Answer to recommendations

Cases studied

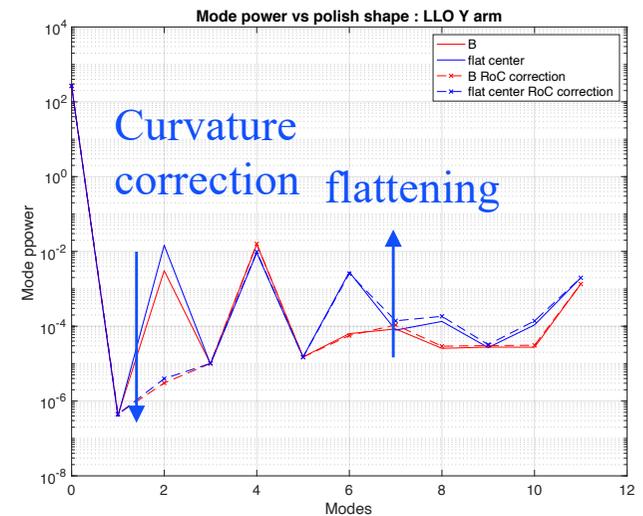
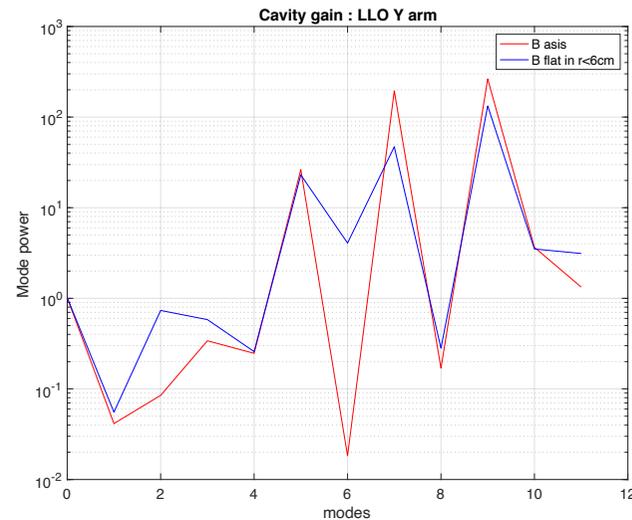
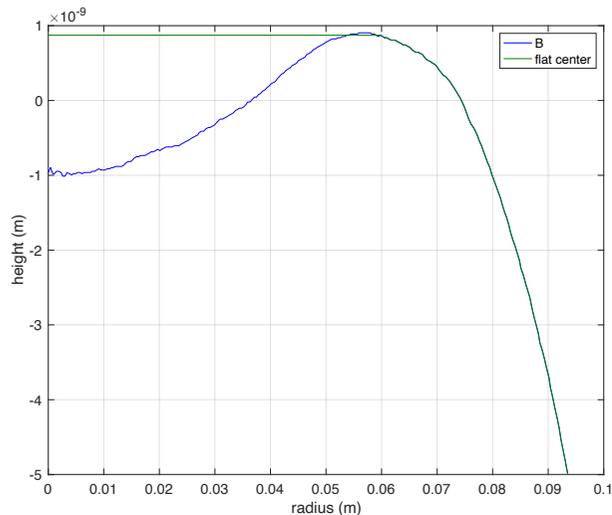
- G2001747-v3, slide 32, upper right plot. Is there any understanding why the RTL for the solid purple curve is lower than for the solid red curve for offsets greater than 2.5 cm ?
A : there was a bug to setup a FP cavity with offset. Needs to be redone.
- Also why is the RTL for the dashed cyan curve higher than for the solid cyan at zero offset?
A : see the answer in the last page. The thermal bump by the coating absorption distorts the field and the edge fall off does not work as is naively expected.
- As the beam is moved, does the absorbed power stay the same, or decrease as it's moved away from the PA?
A : Power changes as $\exp(-2 d^2 / w^2)$ where d is the distance between the beam and the point absorber.

These are plots of ITM and ETM surfaces with 0.35W coating absorption. Bump at the center by the absorption affects the cavity mode a lot.

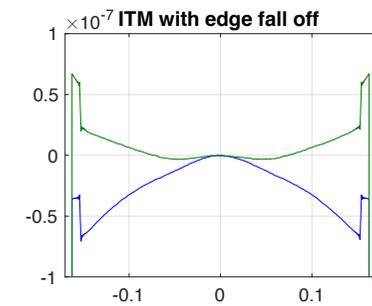
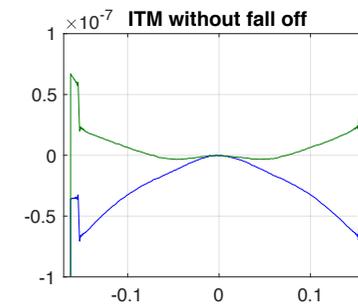
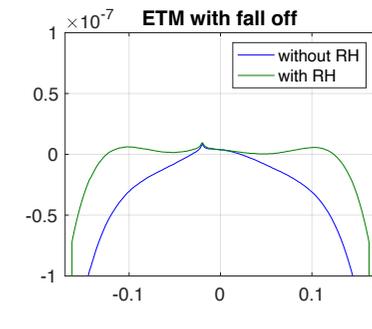
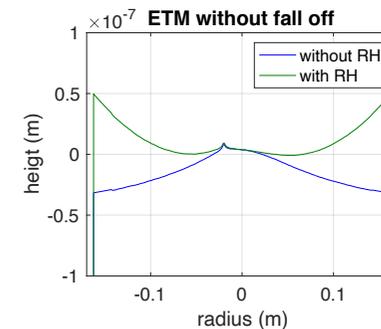
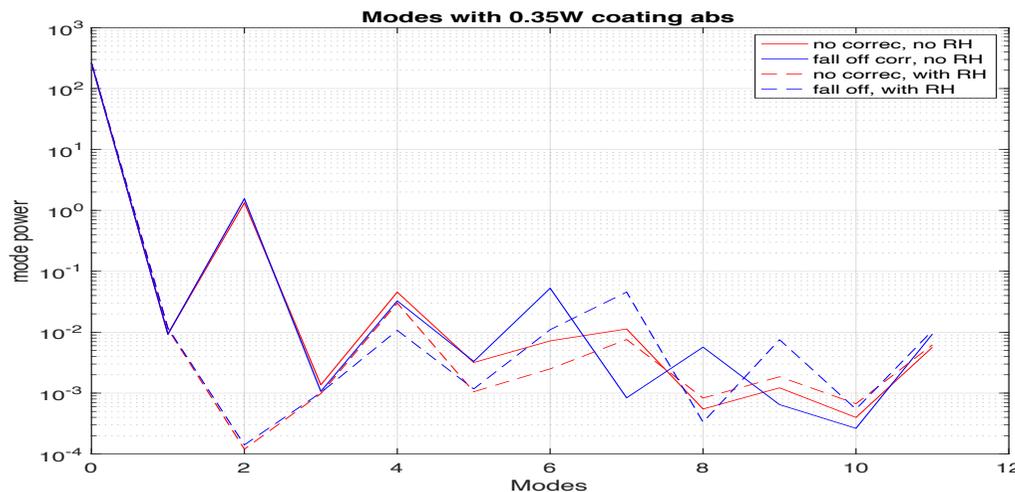
- From G2001747-v3 page 32 - Are labels swapped? Cyan with corr is worse than without at center alignment.

A: labels are not swapped.

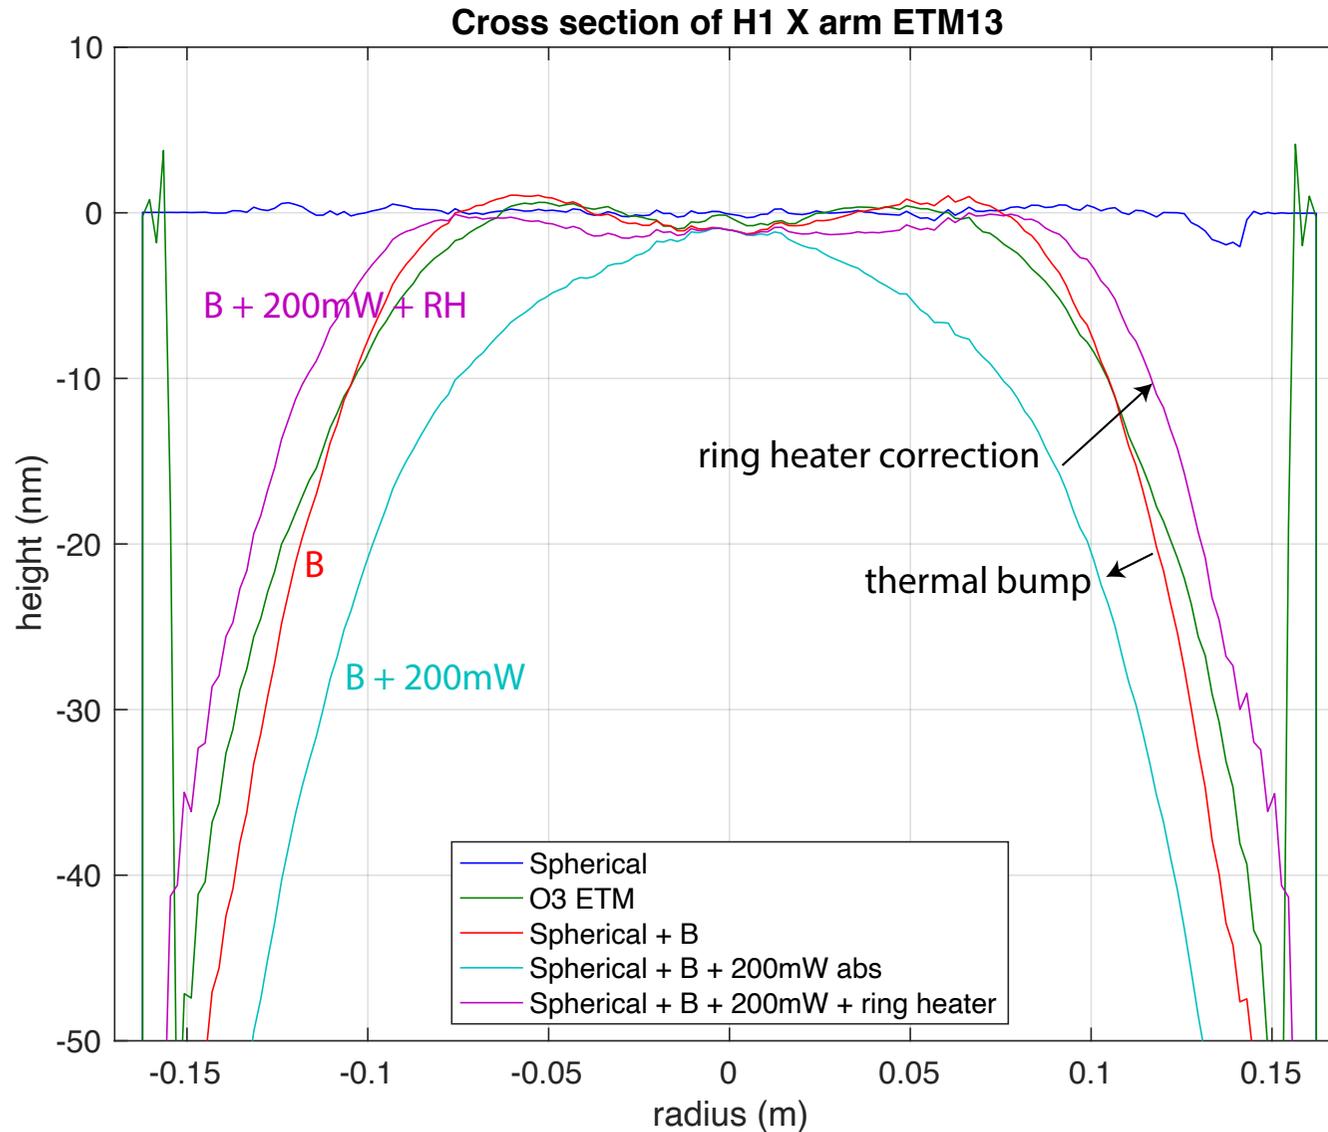
- Also plots on slide 2 - are the axes labels swapped?

A : Yes, axes are swapped
